# HISTORIC AND DESIGN REVIEW COMMISSION

August 17, 2022

**HDRC CASE NO:** 2022-418  
**ADDRESS:** 215 W MARIPOSA  
**LEGAL DESCRIPTION:** NCB 9012 BLK 6 LOT 54 & 55  
**ZONING:** R-4, H  
**CITY COUNCIL DIST.:** 1  
**DISTRICT:** Olmos Park Terrace Historic District  
**APPLICANT:** ANA LITOFISKY/ANA LITOFISKY  
**OWNER:** ANA LITOFISKY/ANA LITOFISKY  
**TYPE OF WORK:** Window replacement, chimney removal  
**APPLICATION RECEIVED:** July 14, 2022  
**60-DAY REVIEW:** Not applicable due to City Council Emergency Orders  
**CASE MANAGER:** Rachel Rettaliata

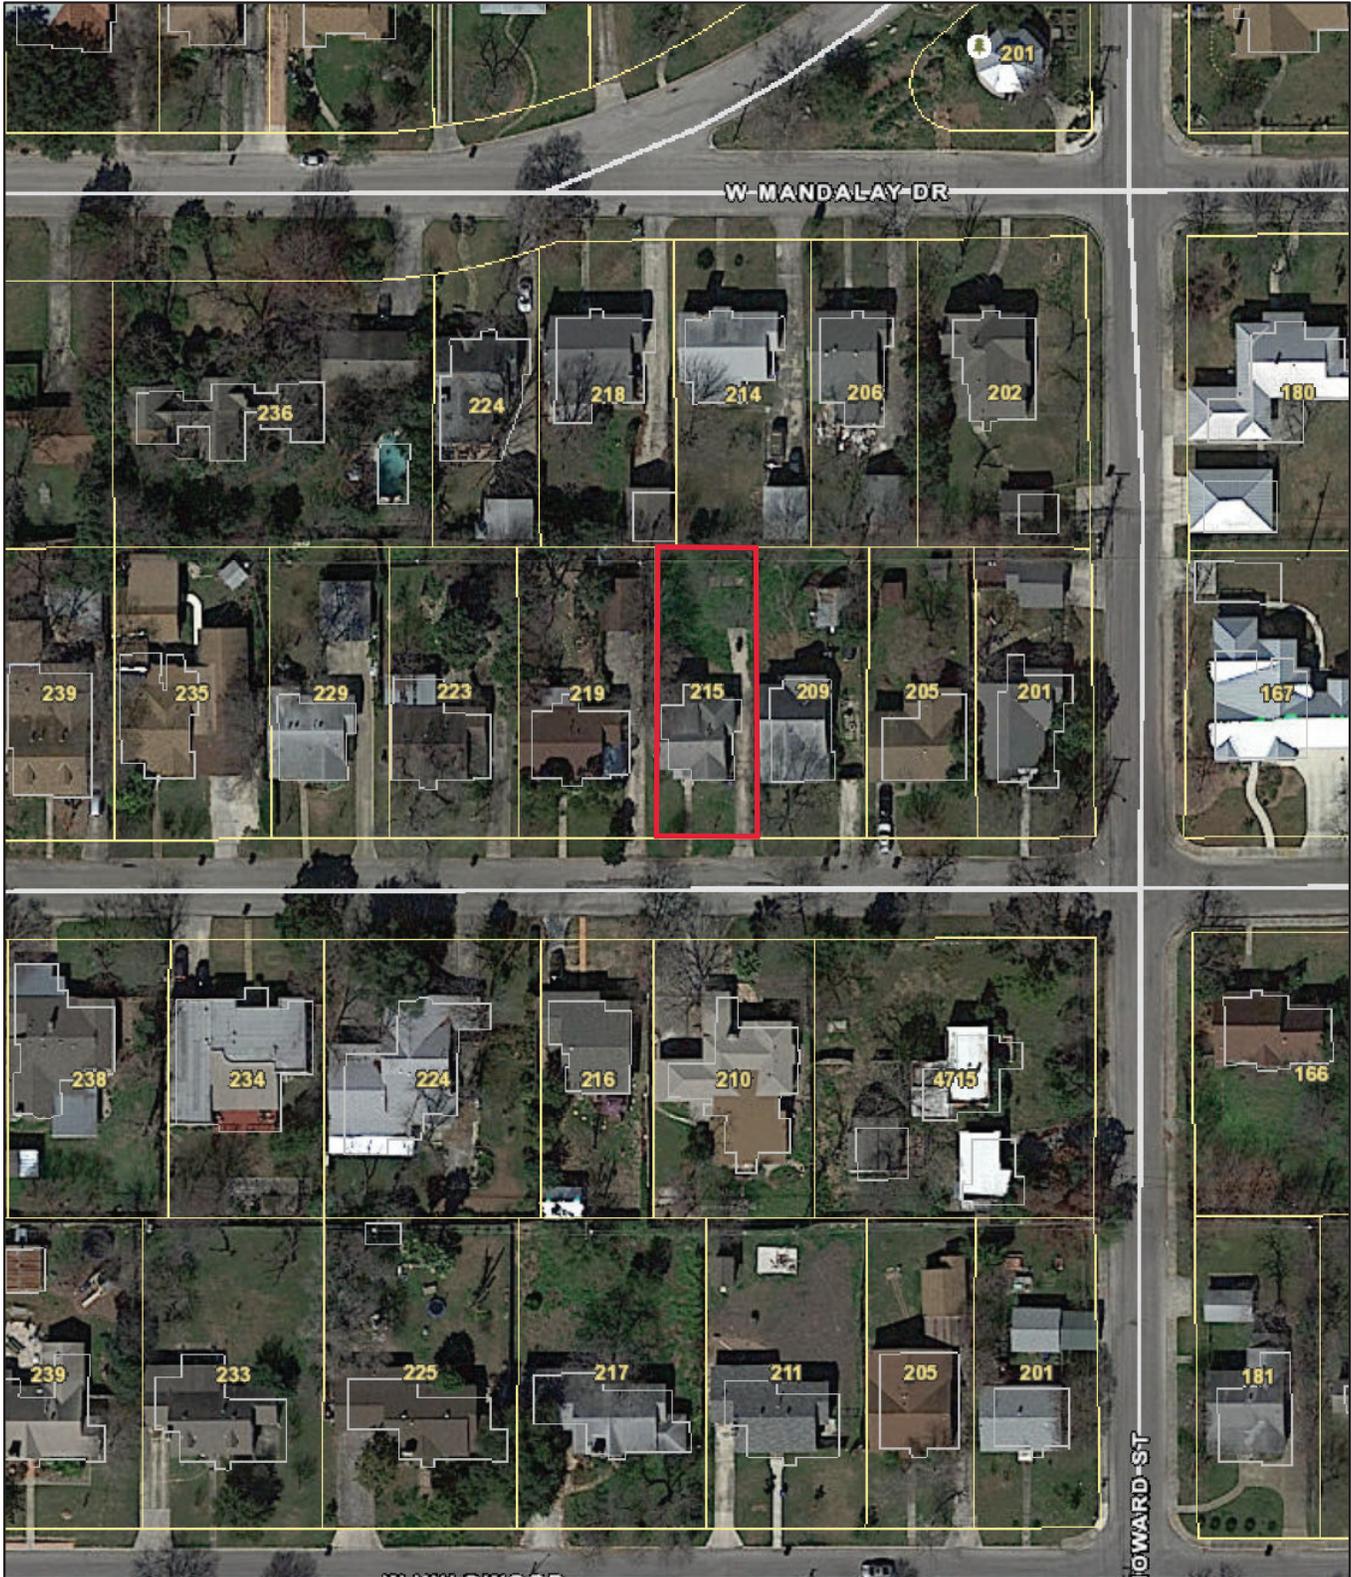
- a. The primary structure located at 215 W Mariposa is a 1-story, single-family residence constructed circa 1940 in the Minimal Traditional style. The structure features a side gable composition shingle roof with minimal eave overhang and a prominent front gable, a stone chimney, one-over-one wood windows, and vinyl siding. The property is contributing to the Olmos Park Terrace Historic District.

- b. COMPLIANCE – The applicant was issued a Stop Work Order in November 2021 for work without approval, including chimney removal and the replacement of seven (7) one-over-one wood windows with vinyl windows. The property is currently in violation.

- c. CHIMNEY REMOVAL – The applicant has proposed to remove an existing stone chimney. The chimney is located on the west side of the primary structure and is highly visible from the public right-of-way. According to Guideline 3.B.vii, existing historic roof vents should be maintained. When deteriorated beyond repair, replace roof vents in-kind or with one similar in design and material to those historically used when in-kind replacement is not possible. The applicant has expressed that the chimney is no longer functional. The prominent chimney is a character-defining feature of the Minimal Traditional structure and relates to the development pattern of the Olmos Park Terrace Historic District. Staff does not find chimney removal consistent with the Guidelines.

- d. WINDOW REPLACEMENT: EXISTING CONDITION – At the time of application, seven (7) original wood windows had been removed and replaced with vinyl windows. The original wood windows were not salvaged; however, one window unit remains on site. Based on photos submitted, the remaining wood windows appear to be in repairable condition and may require minimal repair and intervention such as the reworking of the sashes, the replacement of a single sash element, and reglazing, along with refitting into the trim and frames. The applicant has proposed to repair the remaining wood windows.

- g. WINDOW REPLACEMENT – The applicant has proposed to replace seven (7) existing wood windows with Ply-Gem vinyl replacement windows featuring a faux grid. The seven (7) replacement windows are located on the front façade, the east elevation, and the rear elevation. According to the Historic Design Guidelines, wood windows should be repaired in place and restored whenever possible, unless there is substantial evidence that the windows are deteriorated beyond repair. Guideline 6.B.iv for Exterior Maintenance and Alterations states that new windows should be installed to match the historic or existing windows in terms of size, type, configuration, material, form, appearance, and detail when original windows are deteriorated beyond repair. Staff finds that the proposed replacement product is not appropriate or consistent with the Guidelines. The applicant should install fully wood one-over-one windows to match the previously existing windows in material, dimension, configuration, and profile.

Item 1, staff does not recommend approval of the chimney removal based on findings a through c. Staff recommends that the chimney is reconstructed to match the previously existing chimney in material, profile, and design. The applicant is required to submit a drawing of the chimney to staff for review and approval prior to the issuance of a Certificate of Appropriateness showing that the reconstruction will match the previously existing chimney.

Item 2, staff does not recommend approval of the installation of vinyl windows based on findings d through g. Staff recommends that the applicant installs fully wood windows that meet the following stipulation:

- i. That the applicant installs fully wood windows that feature an inset of two (2) inches within facades and should feature profiles that are found historically within the immediate vicinity. Meeting rails must be no taller than 1.25” and stiles no wider than 2.25”. White manufacturer’s color is not allowed, and color selection must be presented to staff. There should be a minimum of two inches in depth between the front face of the window trim and the front face of the top window sash. This must be accomplished by recessing the window sufficiently within the opening or with the installation of additional window trim to add thickness. Window trim must feature traditional dimensions and architecturally appropriate sill detail. Window track components must be painted to match the window trim or concealed by a wood window screen set within the opening. Faux grids are not permitted. The applicant is required to submit updated specifications to staff for review and approval prior to the issuance of a Certificate of Appropriateness.

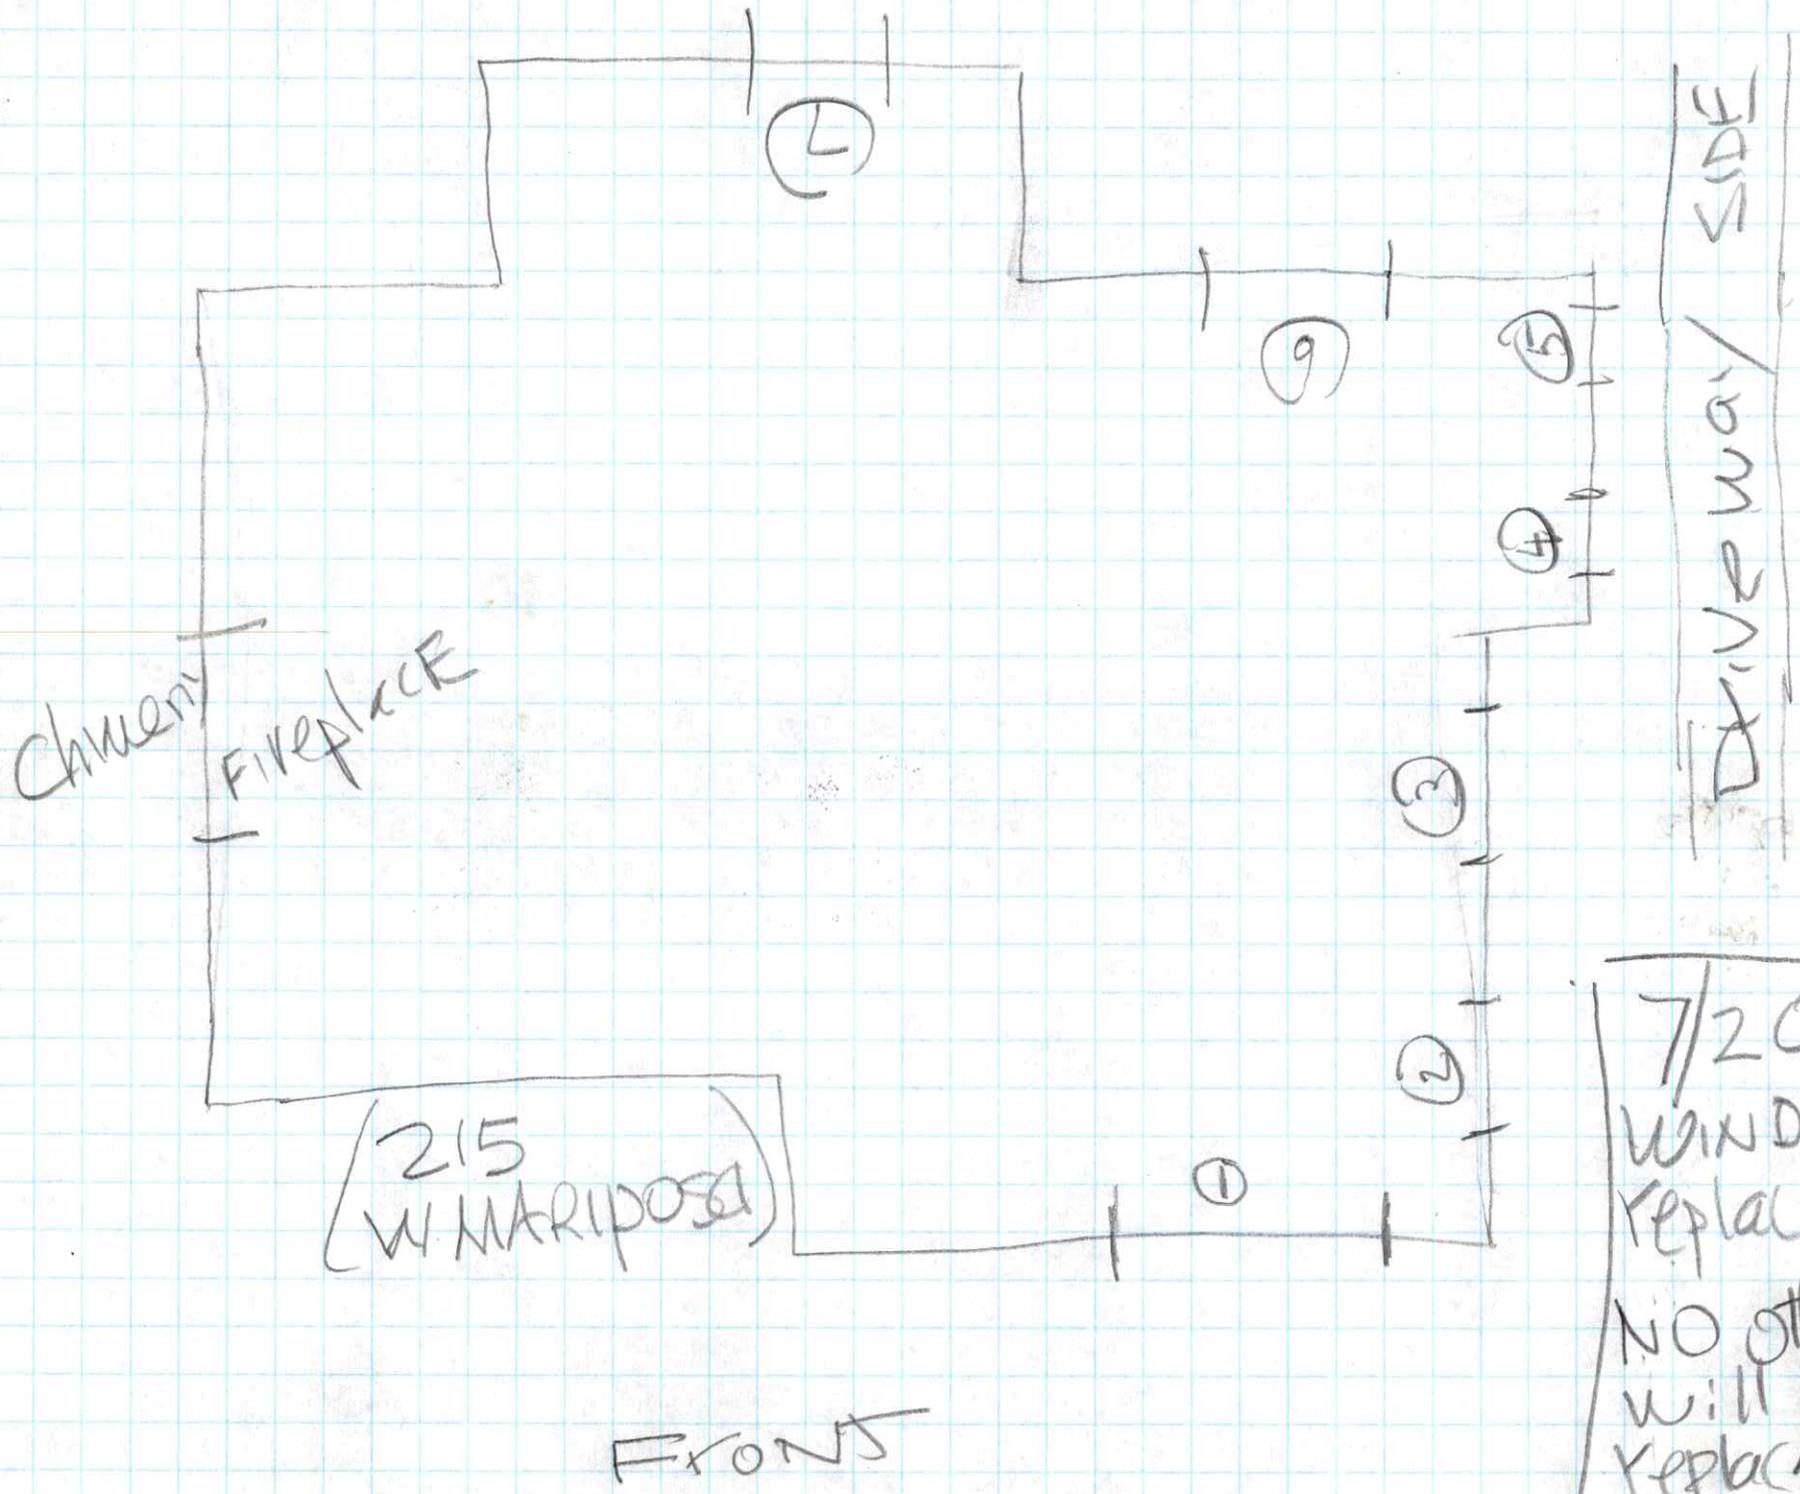
7/20  
 WINDOWS  
 REPLACED  
 NO OTHERS  
 WILL BE  
 REPLACED

## Investigation Report

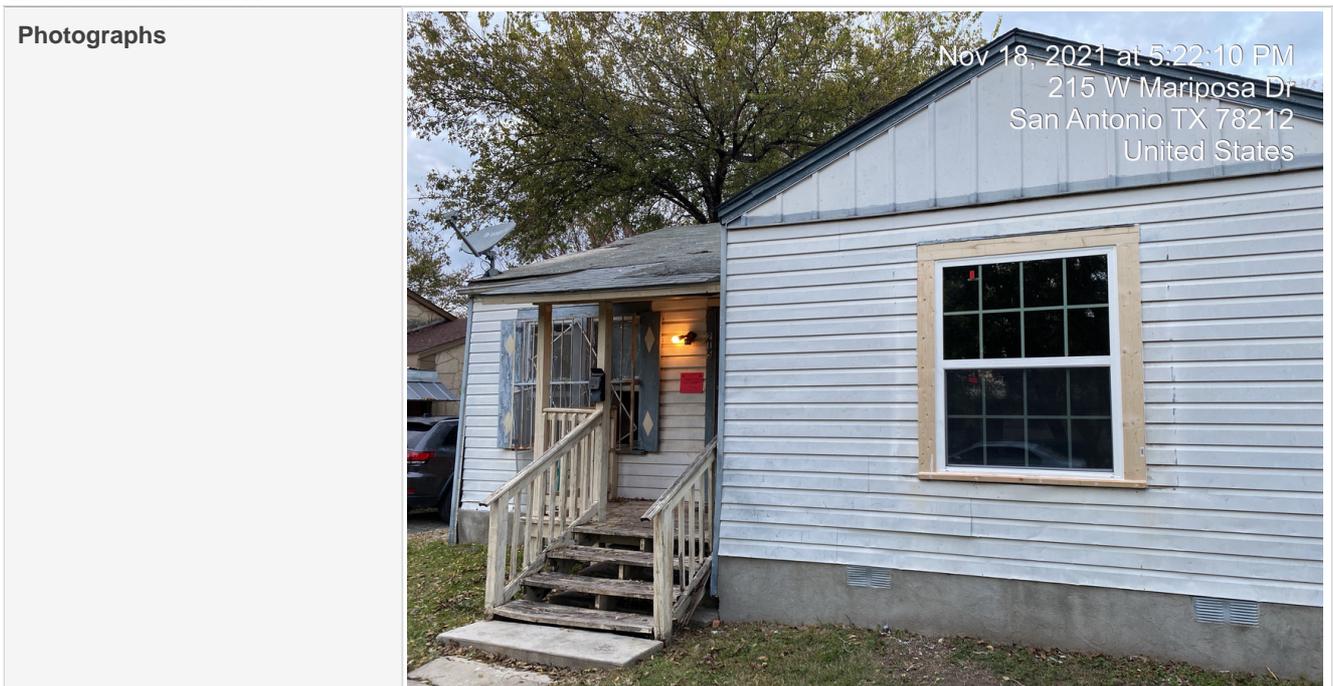
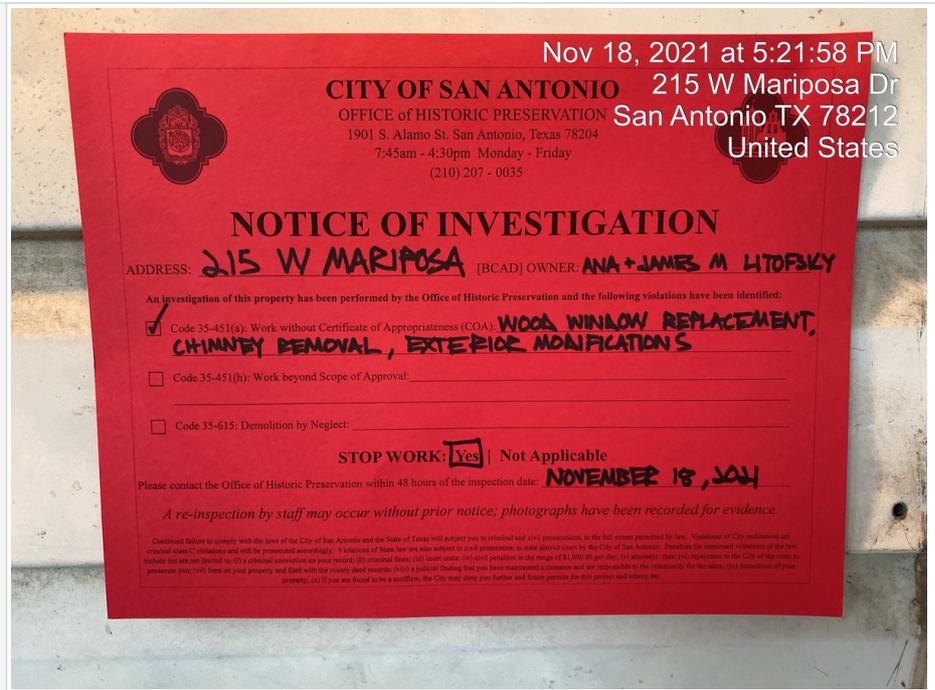
Date	11/18/2021
Time	05:20 PM (-6 GMT)
Context	citizen report
Present Staff	Edward Hall
Present Individuals	None
Types of Work Observed	Exterior Maintenance and Alterations
Amount of Work Completed	50%
Description of work	Removal of masonry chimney, fenestration modifications, exterior modifications, window replacement.

Violation Type	No Certificate of Appropriateness (Code 35-451a)
OHP Action	Posted "Notice of Investigation", Posted additional "Stop Work Notice"
Will post-work application fee apply?	Yes
